AGENDA

Village of Chenequa Plan Commission
Monday, May 12, 2025 at 6:00 p.m.
31275 W. County Road K, Chenequa, WI 53029

STAFF REVIEW

Subject: Site Plan Review

ELEVATIONS

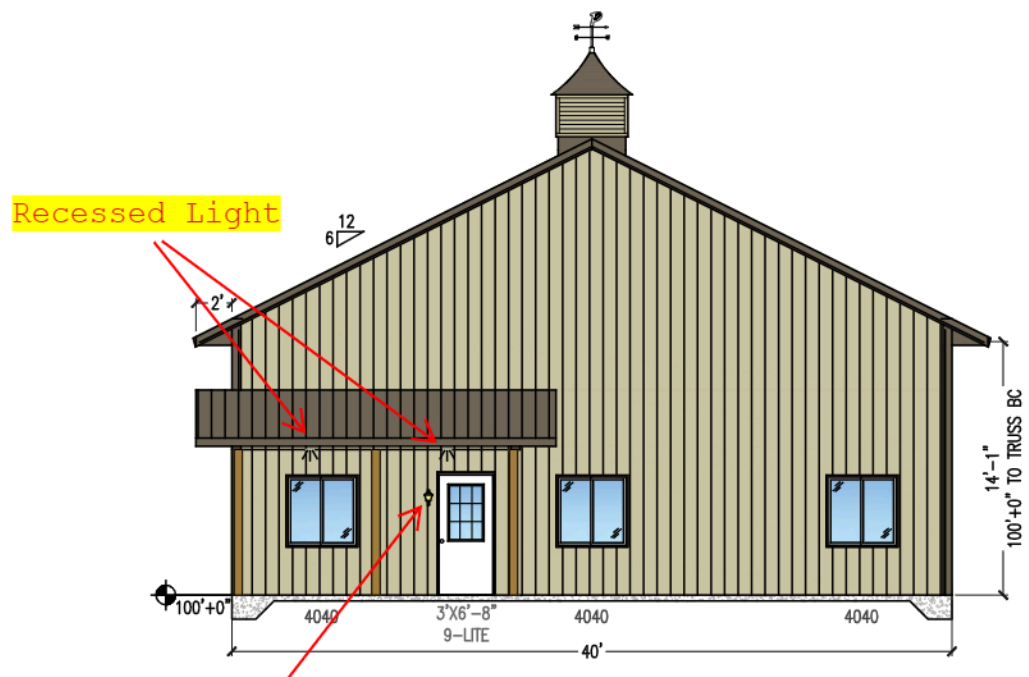
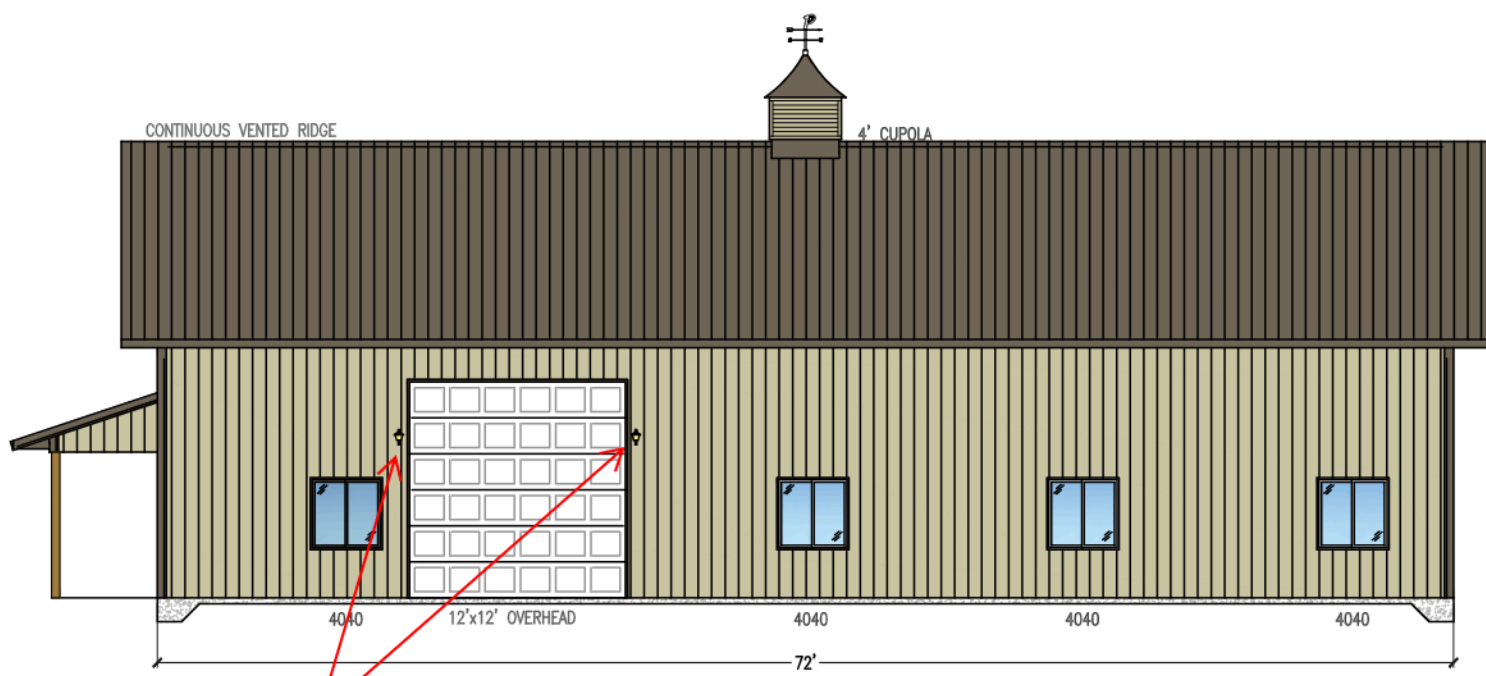
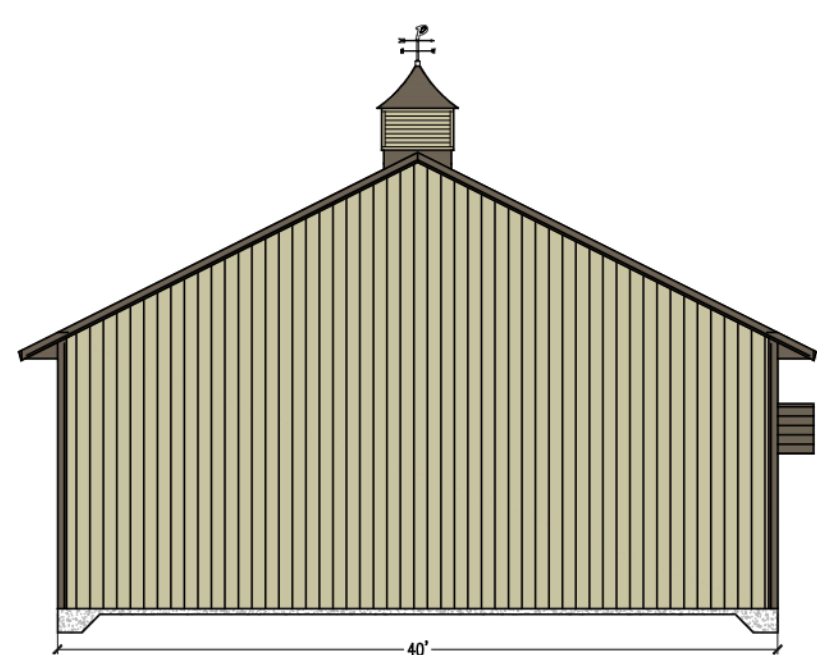
10. Two exterior light options have been submitted
 - a. Wall Lanterns (5)
 - i. The proposed wall lanterns have a fully shielded light source that complies with 5.24.

- ii. The light bulb selected must have a color temperature between 2200K and 3,000K as required in 5.24(5)
 - b. Soffit Lighting (2)
 - i. The proposed soffit lighting is fully recessed and is proposed to be placed under the covered entryway.

- ii. These fixtures are proposed to be 600 lumens each with a color temperature of 3,000 K.
